UNITED STATES PATENT AND TRADEMARK OFFICE

10/593,534

Office Action Summary	Application No. 10/593,534	Applicant(s) HATRICK-SMITH, JOHN	
	Examiner Lori Baker	Art Unit 3751

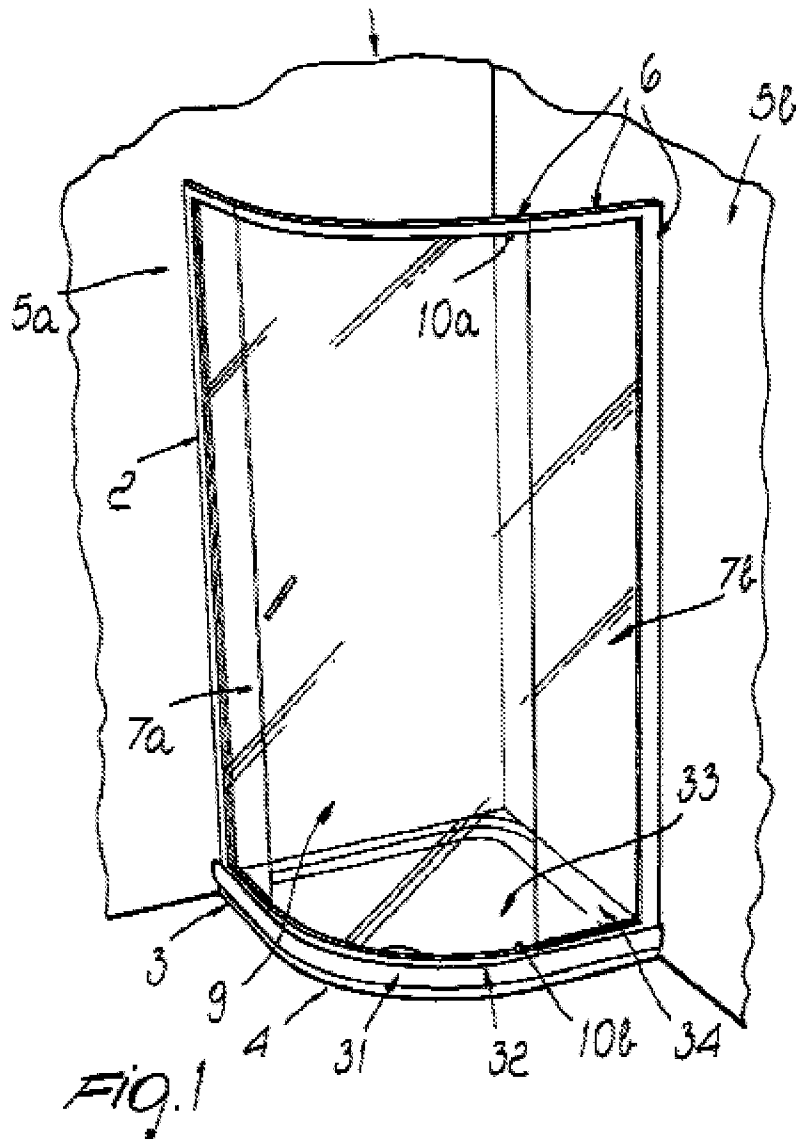
4. Claims 25 and 28 are rejected under 35 U.S.C. 103(a) as being unpatentable over Montanari in view of Payne. The Montanari reference discloses a shower enclosure comprising: a door 9 and return panels 7a/b on both sides of the door; a shower base 3 including a floor 33; a waste outlet 35; a drain channel 34; and a return panel 7a, as claimed. Re claim 25, the "non-sealed gap" is depicted in Fig. 8 Re claim 28, the "non-sealed gap" is depicted in Figure 1 below (see col. 4, lines 5-17 and 28-55). Montanari discloses all of the limitations except for the formations at the edge. Attention is directed to the Payne reference which discloses an analogous shower which further includes a base 1 having a formation 12. Therefore, in consideration of

Payne, it would have been obvious to one of ordinary skill in the shower art to associate a formation with the Montanari base in order to facilitate wall support.

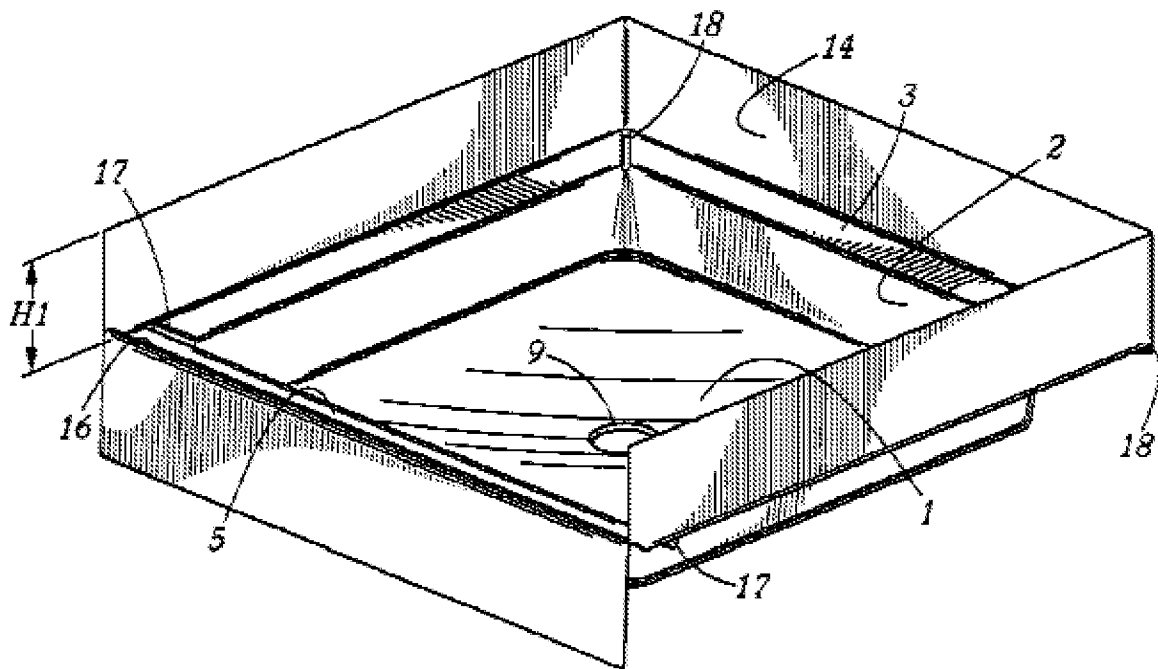
13. Claims 46 and 49 are rejected under 35 U.S.C. 103(a) as being unpatentable over Montanari and Payne and Jurek as applied to claims 25 and 36 above and further in view of Torres (US Patent 7490371). Although Montanari in view of Payne does not have a formation in the form of a step, as claimed, attention is directed to Torres. An analogous art, Torres reference teaches in figure 3, a formation having a step 2, 3 formed at a peripheral edge of the floor of the shower base to receive a foot of the return panel from the shower base. Therefore, in consideration of Torres, it would have been obvious to one of ordinary skill in the shower art to associate a formation comprising a step with the base in order to support the panel/door away from the base surface.

Fig. 2

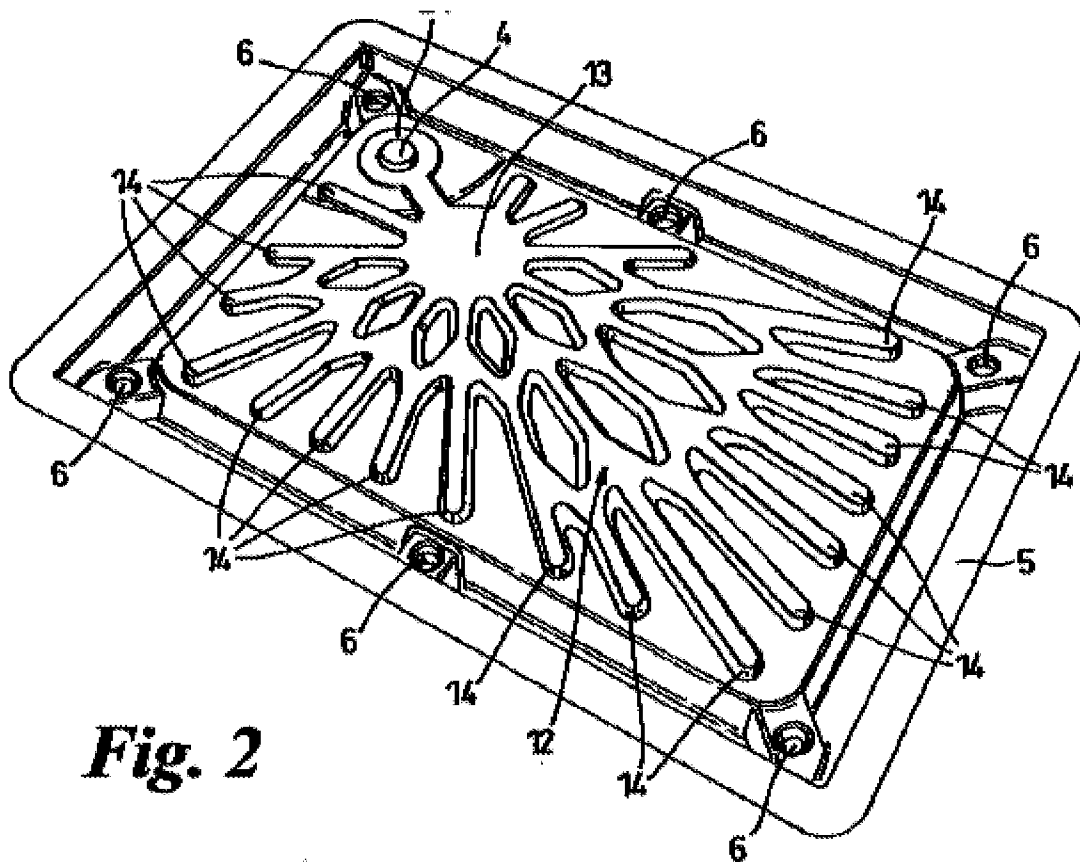
(PG PUB 20060182926. Although Montanari in view of Payne do not disclose cut-outs in the base, as claimed, attention is directed to Lewis. The Lewis reference teaches in the figure below, a cut-out 6, 13, 14, 4 in the analogous shower base. Therefore, in consideration of Lewis, it would have been obvious to one of ordinary skill in the shower art to associate cut-outs with the base in order to support the panel/door away from the base surface.
